Project #: PR-2022-007805 (Third Submittal);
SP-2025-00084 Application #: _____

Description: Site Plan Administrative DFT - resubmittal for Pacific Fusion, known a Project Solis.

Re: Project Solis —Tract J Bulk Land Plat for Mesa del Sol Innovation Park II (101605115947920604)
Project No: PR-2022-007805 (Third Submittal); SP-2025-00084
EPC Plan No: FP-2025-00004

On behalf of Project Solis, Stantec Architecture Inc. respectfully submits this supplemental submission of minor design revisions for final DFT review and approval. The proposed substitutions adhere to the preliminary approvals and findings stated in the EPC *Official Notice of Decision*, dated Aug. 21, 2025 (Plan# FP-2025-00004), and remain in full compliance with the City of Albuquerque IDO codes and regulations. The following revisions have been submitted concurrently to Mesa Del Sol ARC for Step II amendment review and approval.

1 ARCHITECTURAL - SITE PLAN
 SCALE: 1" = 50'-0"

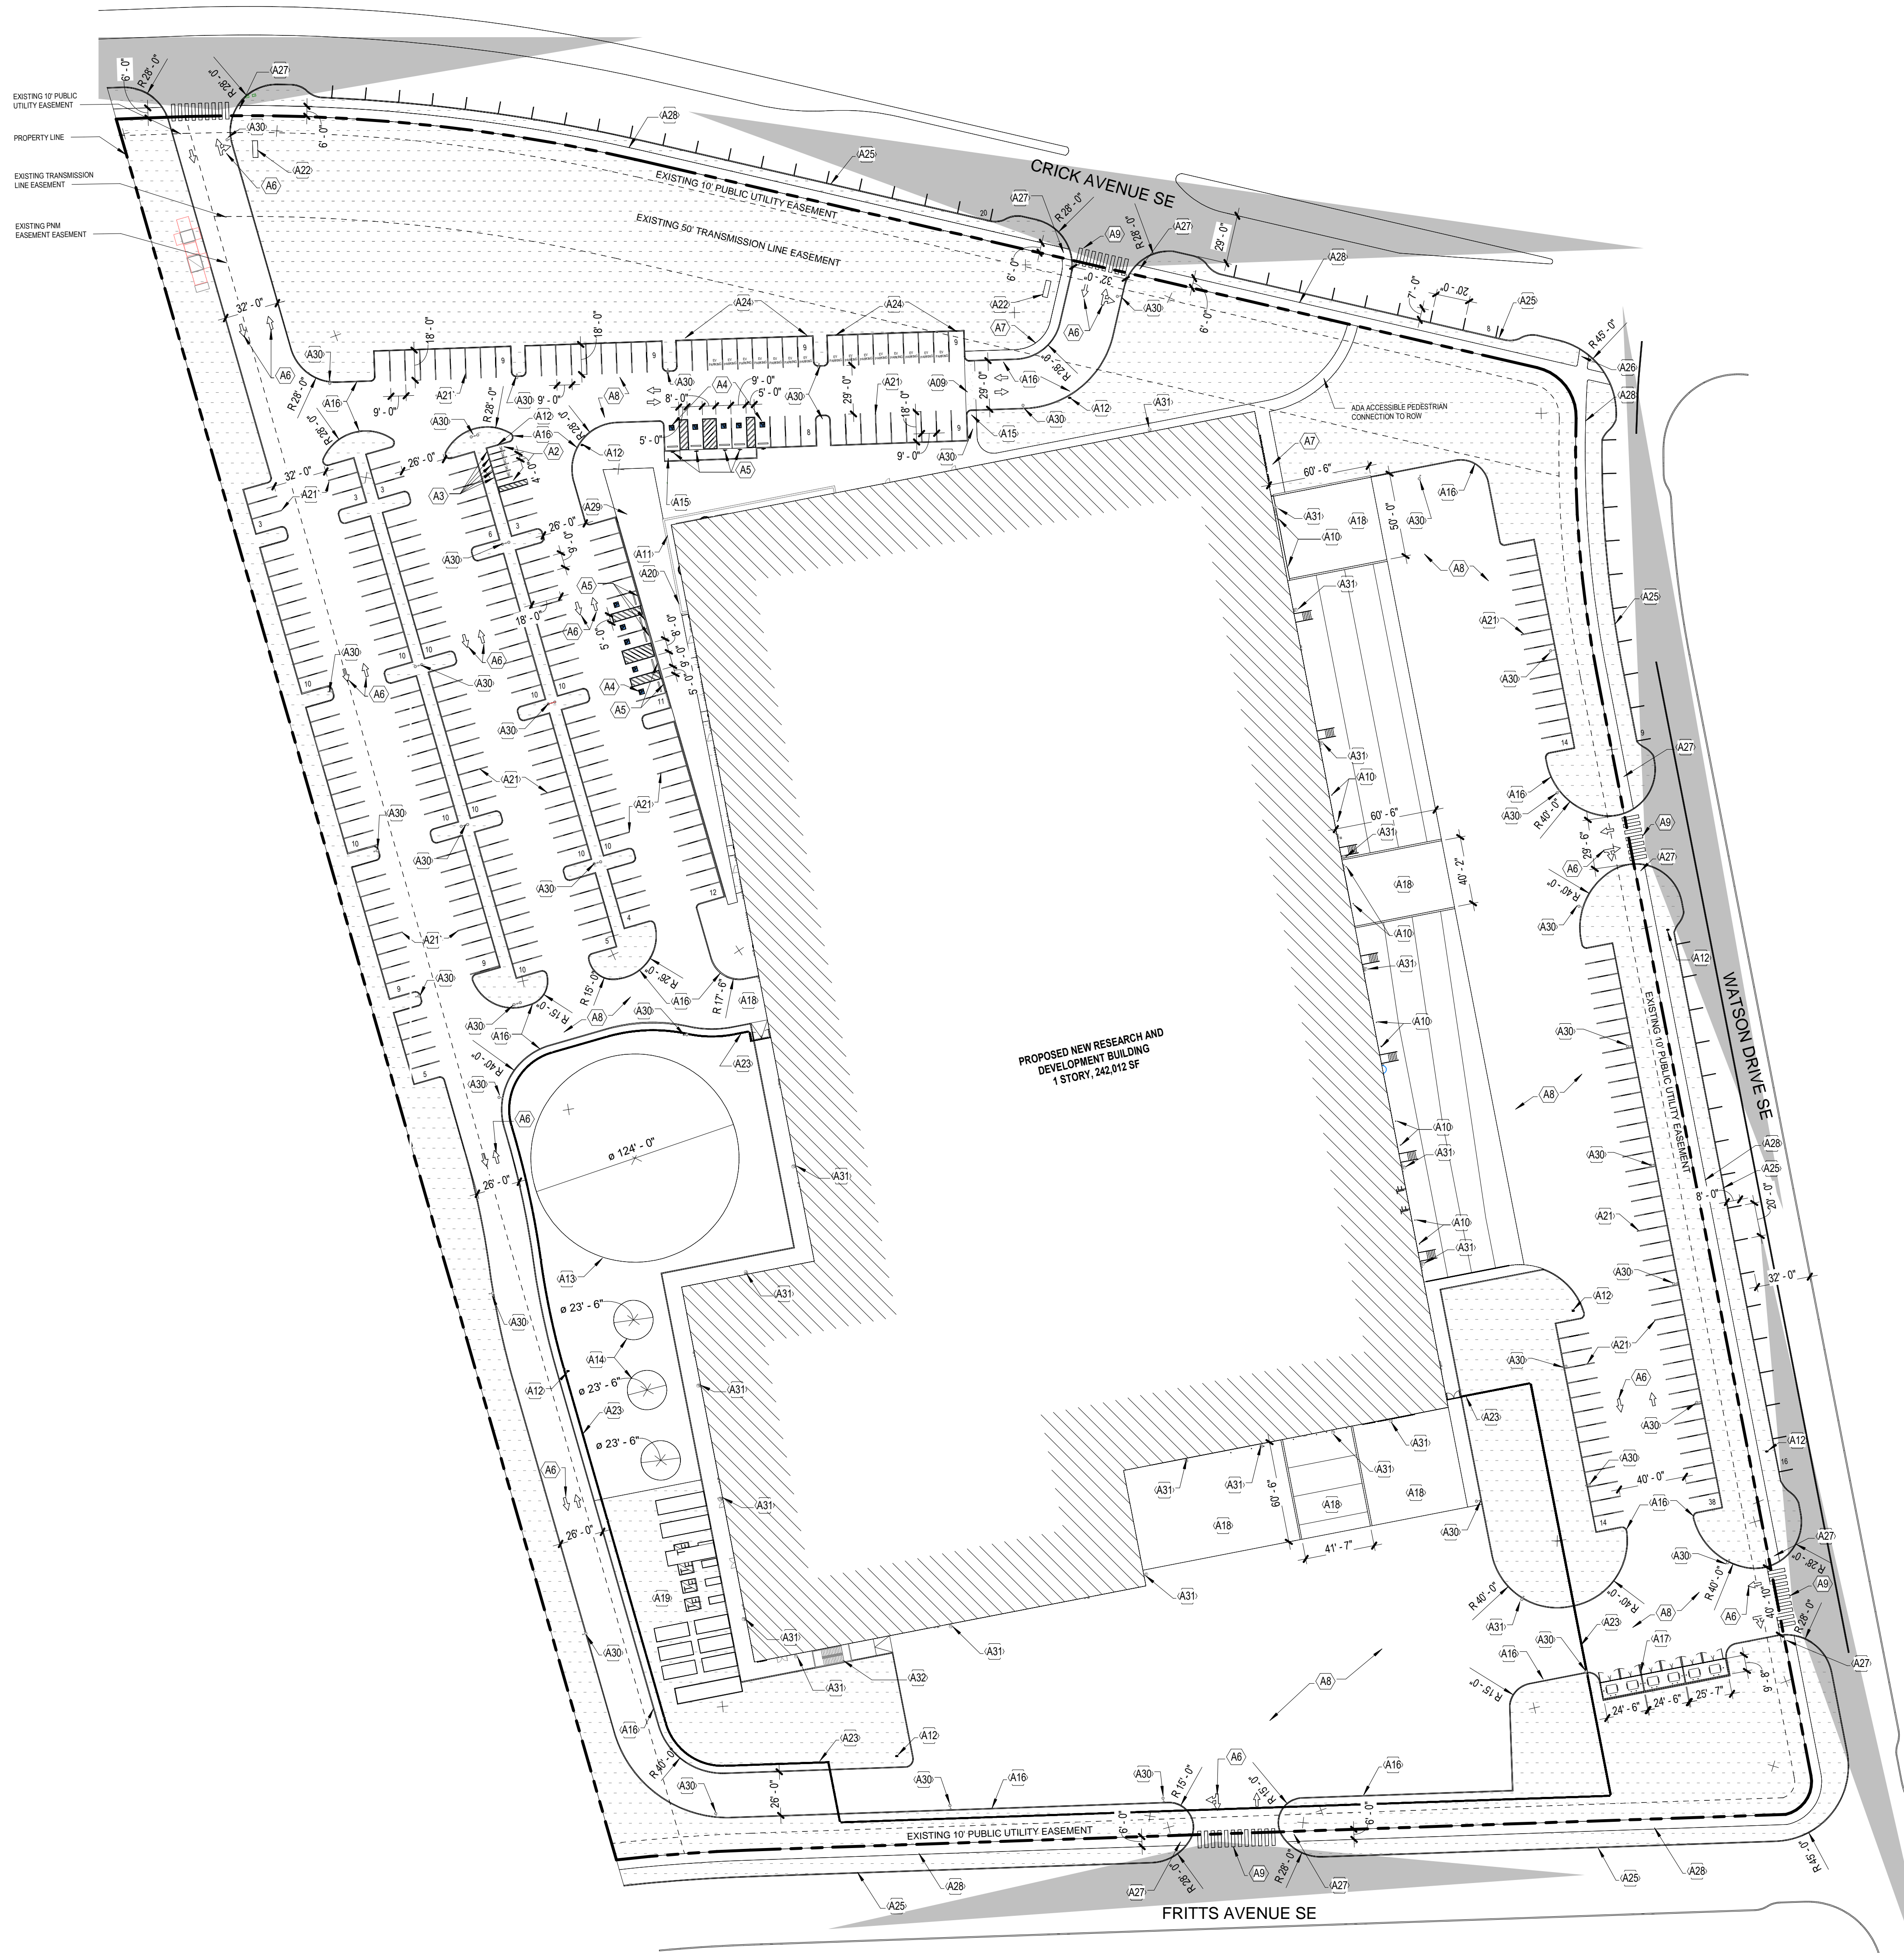
Overall Site Plan – The following revisions have been made to the site design and associated drawings. Based on the total site area of 17.04 acres, 1.67 acres have been impacted by these design revisions – a change of 9.8%. Overall parking increased from 271 spaces to 302 spaces, an increase of 7%. The overall site design was minorly modified to accommodate the larger CUB Facility.

Parking Configuration – Parking has been adjusted around the tank yard, and in various locations throughout the site. Additional parking aisles have been added along the western edge of the site, and near the southeast corner of the building. The overall parking count has increased 7%, to 302 spaces.

Loading Ramps at Building – The two truck loading ramps previously shown at the south of the building have been adjusted and increased in size. Two additional truck loading ramps have also been added to the east side of the building.

1 LANDSCAPE PLAN
Scale: 1"=50'-0"

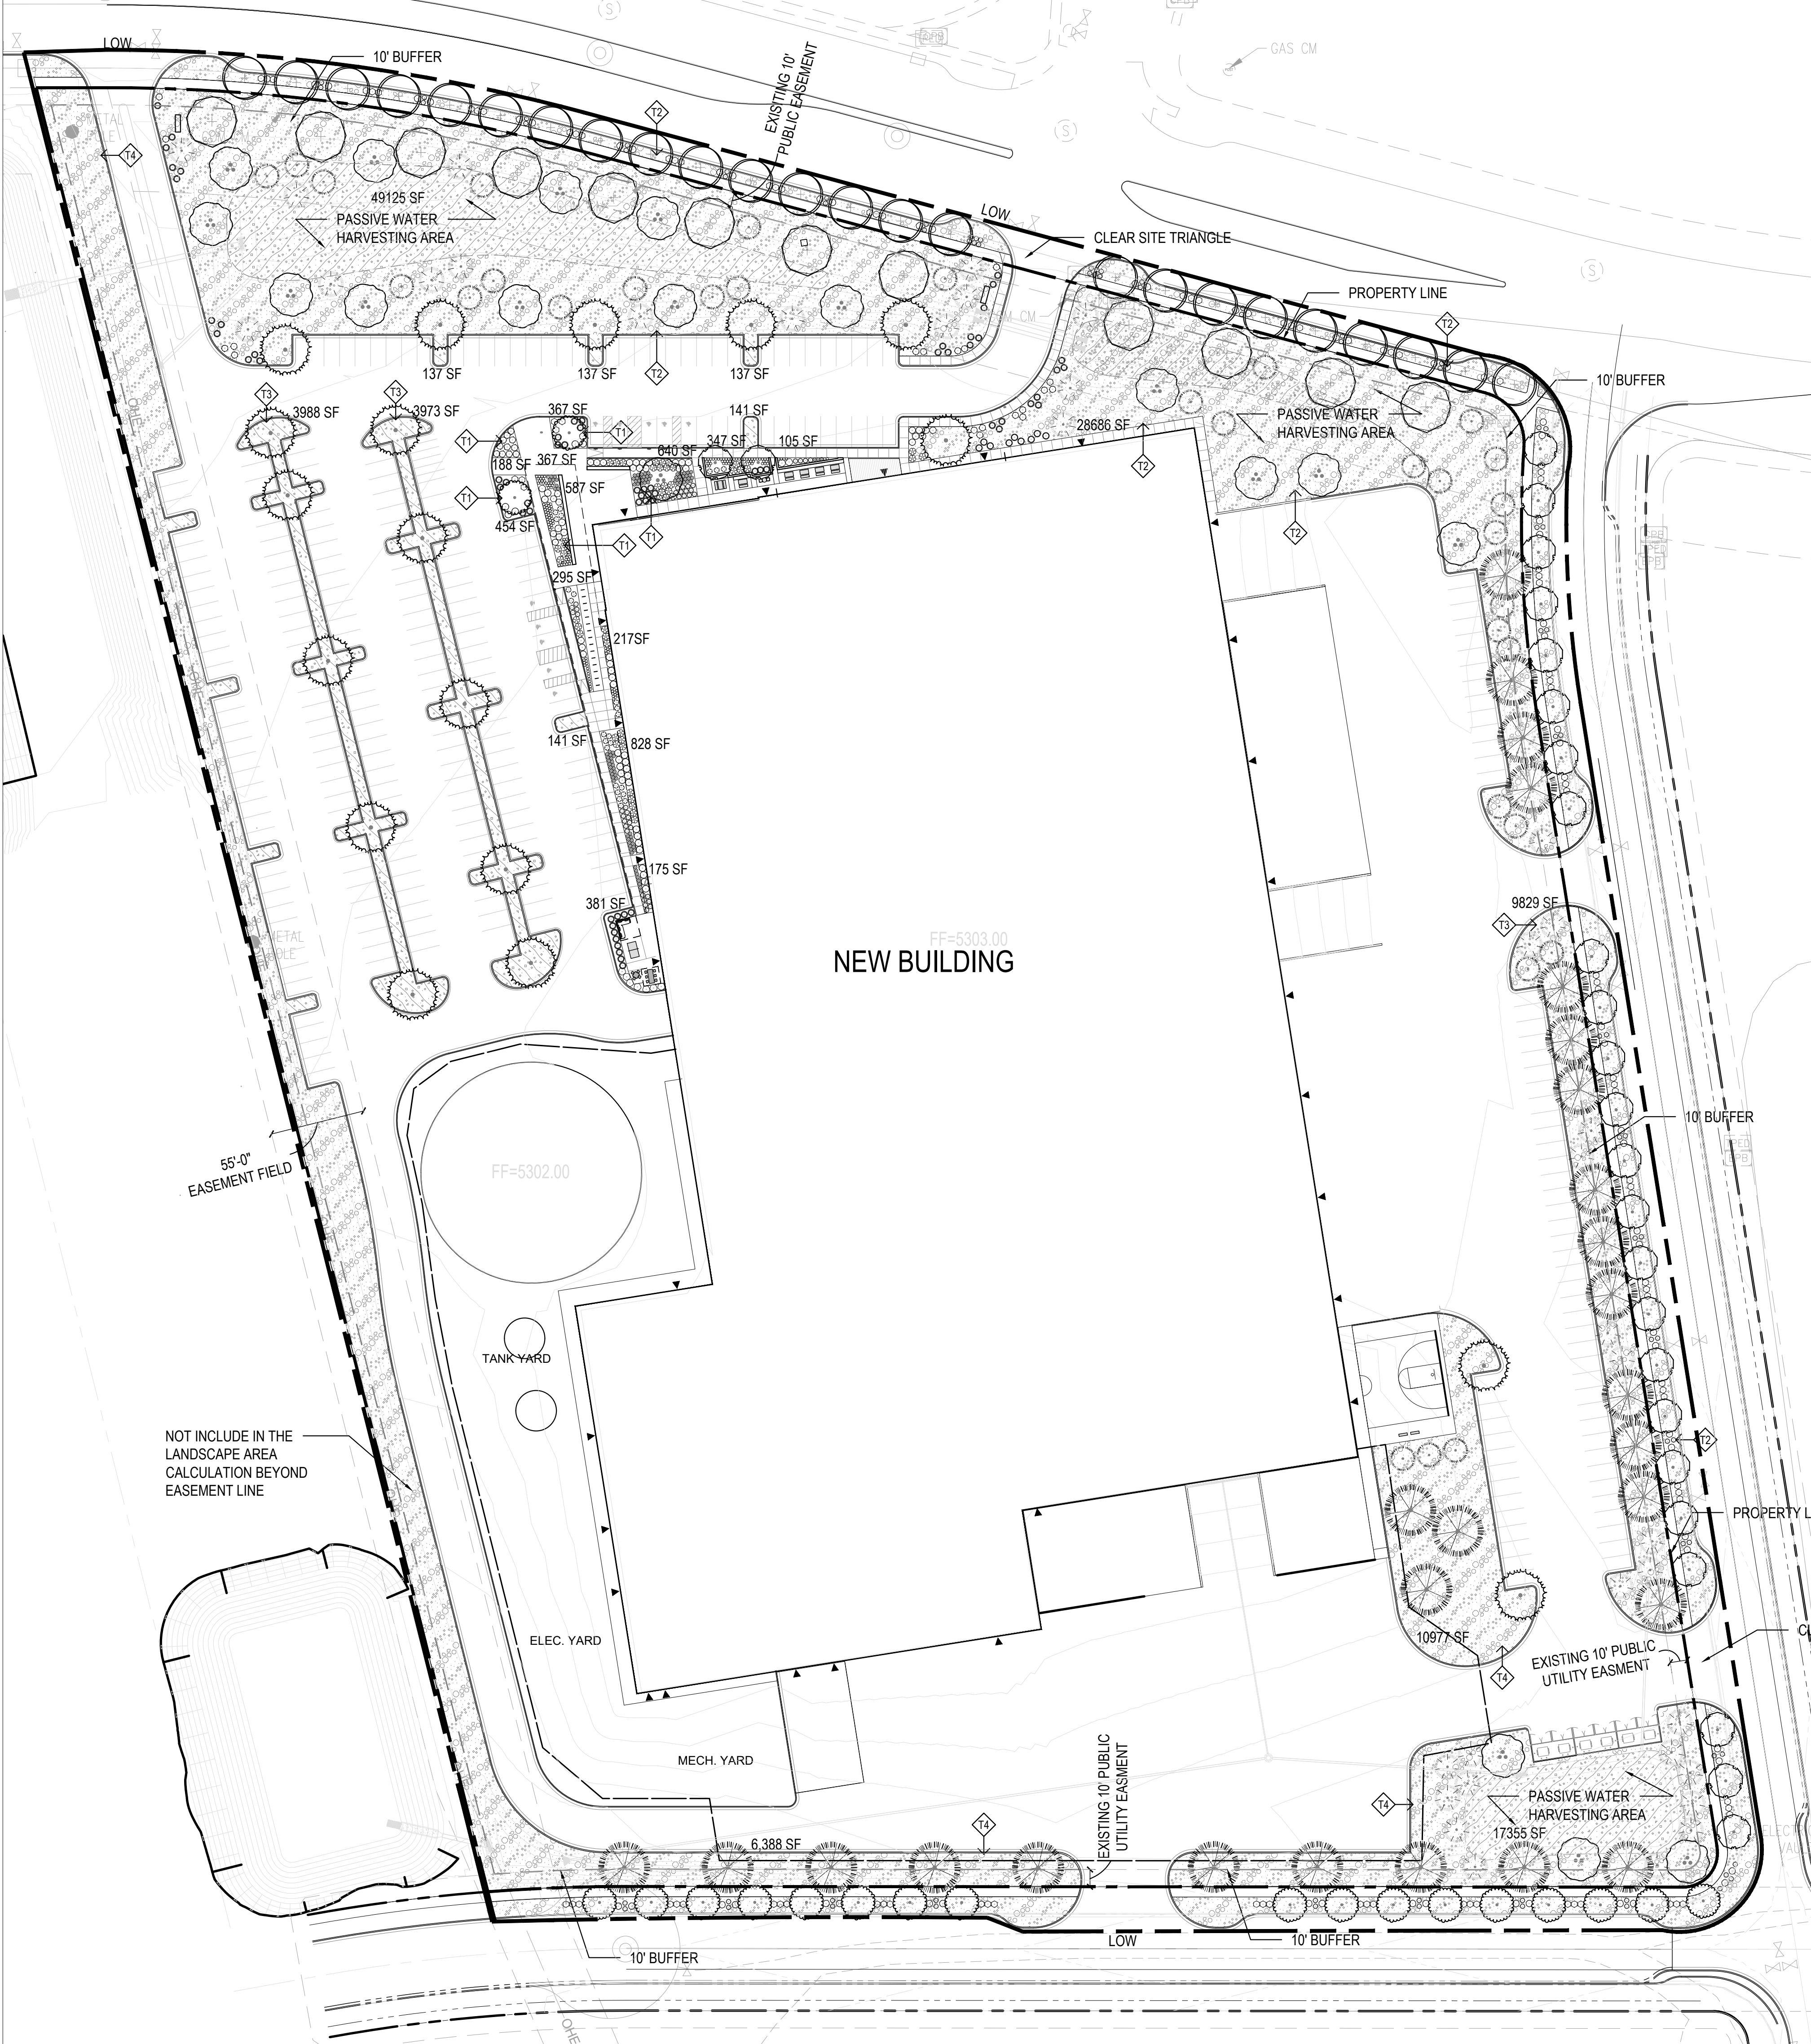
Landscape – Landscape has been reconfigured based on changes to site parking and hardscape. Plant species and coverage remain compliant with City of Albuquerque IDO standards and regulations and Mesa del Sol ARC development guidelines.
